Access Compliance Report

Public Rights-of-Way

Intersection ID: 47850	Main Street: LAGO_VISTA_CT	Cross Street: SERAPE_RD	Location: SE
ADA ID: D2202EB826A0	Ramp Type: PerpDiag	Initial Pass/Fail: Fail	Overall Compliance: No
		Severity Score: 10

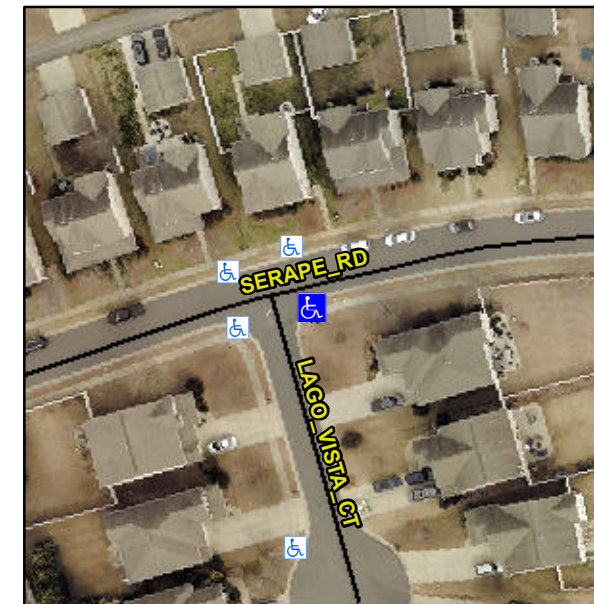
R304.5.1, R304.5.3

Compliance	Description	Data	Compliance	Description	Data
N/A	Ramp Length (in)	48.5	Yes	Ramp Slope (%)	5.9
No	Ramp Width (in)	42.5	No	Ramp XSlope (%)	2.2
N/A	Flare Type LT	N/A	N/A	Flare Type RT	N/A
N/A	Flare Slope LT (%)	N/A	N/A	Flare Slope RT (%)	N/A
N/A	Flare Traversable LT?	N/A	N/A	Flare Traversable RT?	N/A
N/A	Landing Length (in)	N/A	N/A	DWS Provided?	N/A
N/A	Landing Width (in)	N/A	N/A	DWS Contrast?	N/A
N/A	Landing Slope (%)	N/A	N/A	DWS Length (in)	N/A
N/A	Landing X Slope (%)	N/A	N/A	DWS Full Width?	N/A
N/A	Landing Curb? (Y/N)	N/A	N/A	DWS Offset (in)	N/A
N/A	Shared Landing?	N/A			
N/A	Gutter Ponding?	N/A	N/A	Gutter Slope (%)	N/A
N/A	Gutter Lip Ht (in)	N/A	N/A	Gutter X Slope (%)	N/A
N/A	Painted X Walk1?	No	N/A	Painted X Walk2?	No
	X Walk 1 Direction	To N		X Walk 2 Direction	To W
N/A	X Walk 1 Width (in)	N/A	N/A	X Walk 2 Width (in)	N/A
	X Walk 1 Slope (%)	2.8		X Walk 2 Slope (%)	1.9
	X Walk 1 X Slope (%)	0.0		X Walk 2 X Slope (%)	3.2

Remove & Replace Curb Ramp With Two New Directional Ramps or Equivalent.
